NUREG/CR-3300
SAND83-1118
Vol. 1

Review and Evaluation of the Zion Probabilistic Safety Study

Plant Analysis

Figure 3.2.15-1. Comparison of Lognormal Distribution

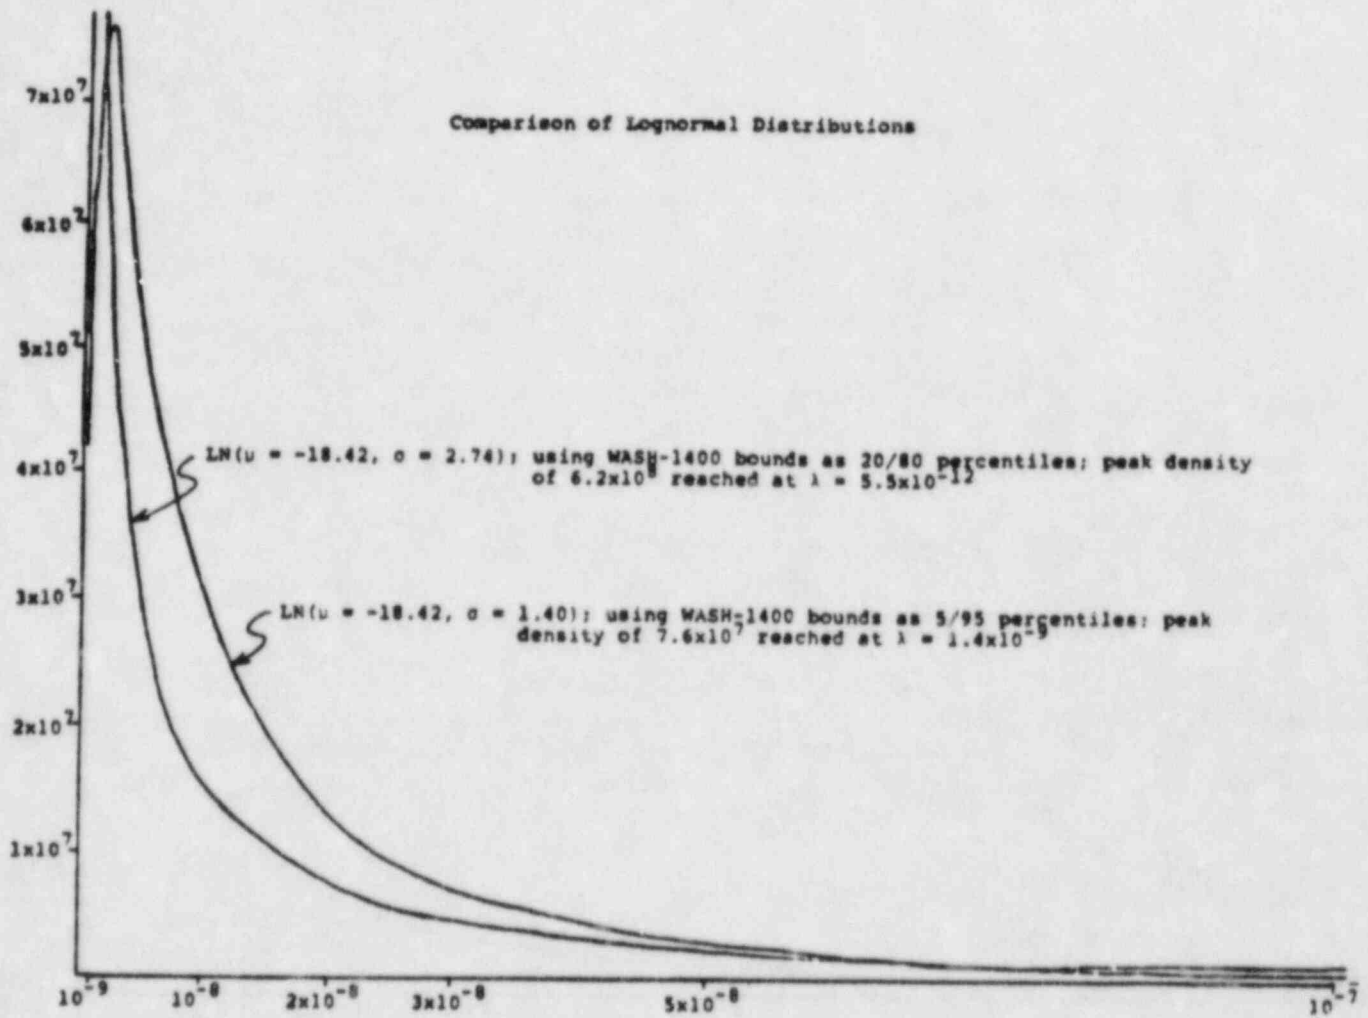
Figure 3.2.15-1 shows the two lognormal distributions just discussed, drawn on a linear scale. Innocent-looking normal distributions on a log-scale transform to greatly skewed distributions on a linear scale. Whether they accurately depict anybody's state of knowledge is open to question. From this figure, the large increase in the variance of λ using the 20/80 assumptions, rather than 5/95, is not at all apparent. However, the 20 percent of the distribution beyond $\lambda = 10^{-7}$ in the former case versus the 5 percent in the latter exerts considerable leverage.

Now consider Zion's model. For the (rupture-rupture) event the downstream valve is not at risk until the upstream valve has ruptured. If it is assumed that the rupture rate of the downstream valve is the same as that of the upstream (as Zion implicitly did), then the probability of both valves rupturing in a period of 1 year is approximately

$(\lambda_2 \tau)^2/2$, where $\tau = 8760$ hrs. This is a factor of two larger than Zion's assumed model. Similarly, for (open-rupture) the downstream valve must transfer open before the upstream valve ruptures, so this event occurs with probability $\lambda_1 \lambda_2 \tau^2/2$, approximately (p. V-43 of WASH-1400 gives a misprinted derivation of this result; no doubt there are other references). Thus the model should be

Figure 1 Demonstration of Truncation of the Attenuation Curves

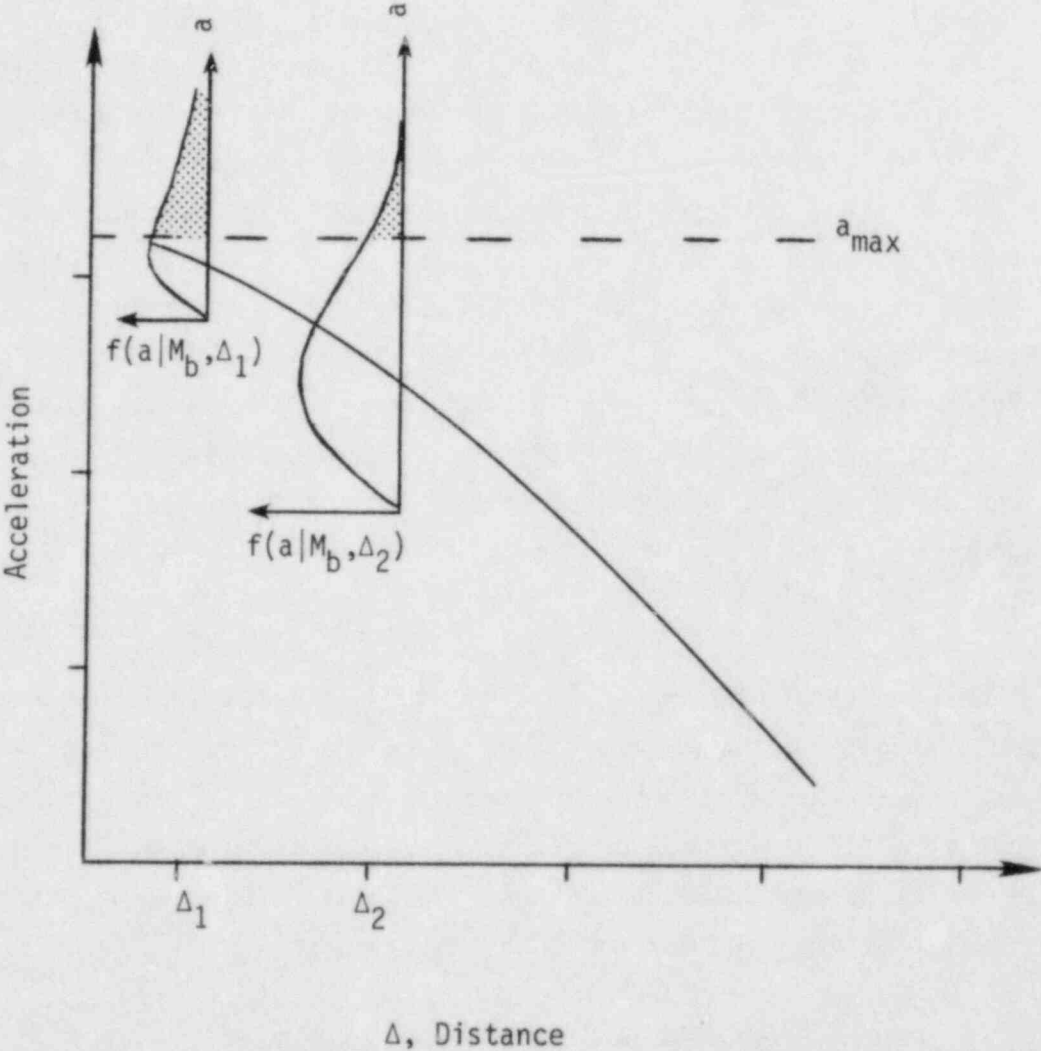
In Section 7.9.1, the lognormal distribution about the attenuation curve has been truncated to reflect the possibility that the effective accelerations are limited. To account for this possibility, three levels of a_{\max} were assumed in the analysis. These a_{\max} values are independent of magnitude and distance. We agree that upper limits on a_{\max} should be considered; however, the manner in which the analysis was conducted is inconsistent with the arguments presented in this section for limiting accelerations on the basis of a dependence on maximum magnitudes (and hence intensities). The approach used in the Zion PRA report requires that the lognormal distribution be normalized (Ref. 5) for each value of M_b and distance (see Figure 1). An alternative approach would have been to truncate the distribution at a level equivalent to a constant number of standard deviations (i.e., $2\sigma_{\ln a}$, $3\sigma_{\ln a}$, etc.), or an a_{\max} which is dependent on M_b and distance. However, we judge that the overall effect on the annual

frequency of exceedance curves, and the frequency of core melt will be small if the distributions were in fact not normalized.

Figure 5 Partial Fragility Curves - Linear Scale

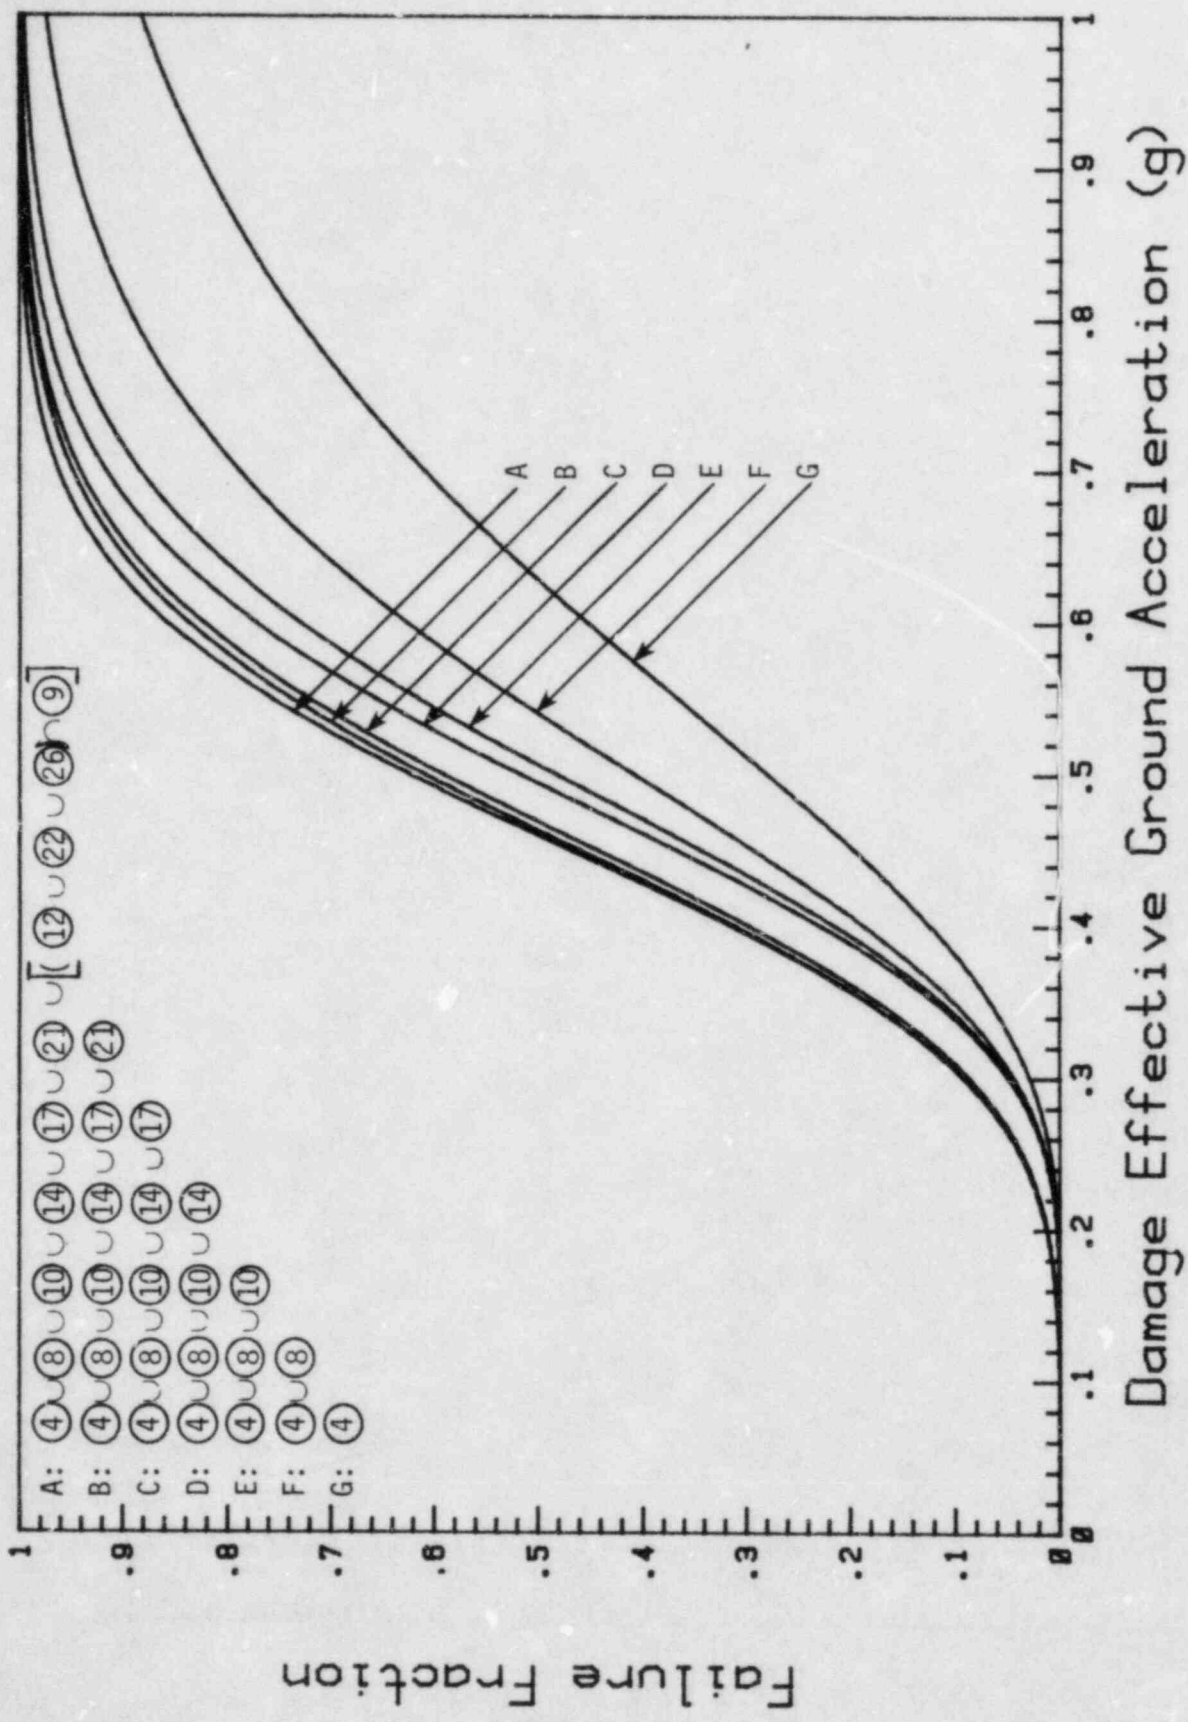
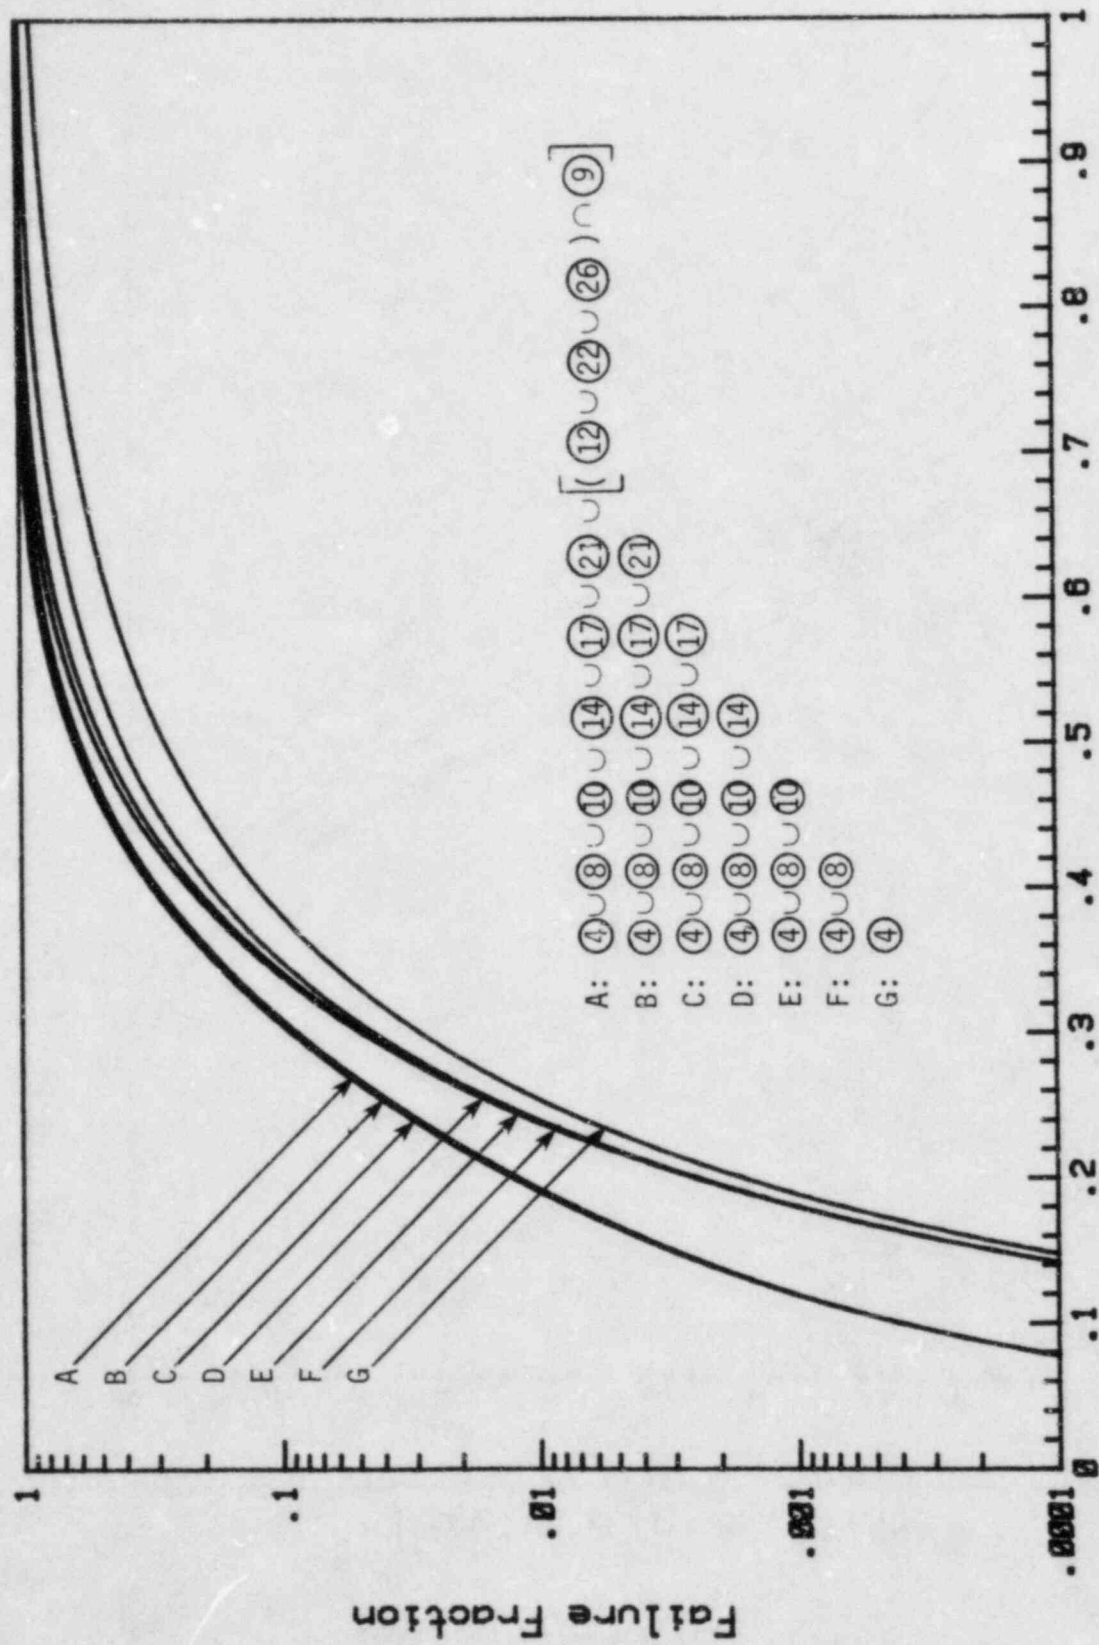
Figures 5 and 6 show the relative contribution of the above-listed ten items to the total frequency of core melt. The failure fraction versus damage effective ground acceleration is shown for linear and logarithmic scales in these two figures. As shown, the curves become progressively higher (i.e., larger failure fraction) as more and more items are included in the Boolean equation for core melt failure. Note that in developing these curves the randomness and uncertainty was combined.

Several observations which give perspective to the importance of each structure or equipment item can be seen from these curves. The most important contributor to core melt is the service water pumps, which are the weakest components. The next most important item is the Auxiliary Building shear wall. As explained previously, the integration

of the hazard and fragility curves depends primarily on acceleration values above 0.3g. For ground accelerations above 0.3g, neglecting the contribution (i.e., based on the fragility parameter given in the Zion PRA report) from all other structures or equipment, would result in underestimating the failure fraction by a factor of only three (a moderate effect). In terms of the probability distribution of the frequency of core melt (i.e., Figure 7.2-5), the mean value would also follow this same relationship. However, the lower tail of the density function would be more severely affected by the elimination of other items. Thus, in order for a major change to occur in the mean frequency of core melt due to fragility effects, the strengths of a number of the structure or equipment items would have to drop down to or below the strength of the service water pumps (or the strength of the service water pumps would have to decrease).

A jump in the probability of failure occurs when item ①⑦, which is the 125 VDC batteries and racks, is included in the Boolean expression (see Figure 6). This is due to the relatively high uncertainty value (i.e., $\beta_u = 0.63$) for this equipment.
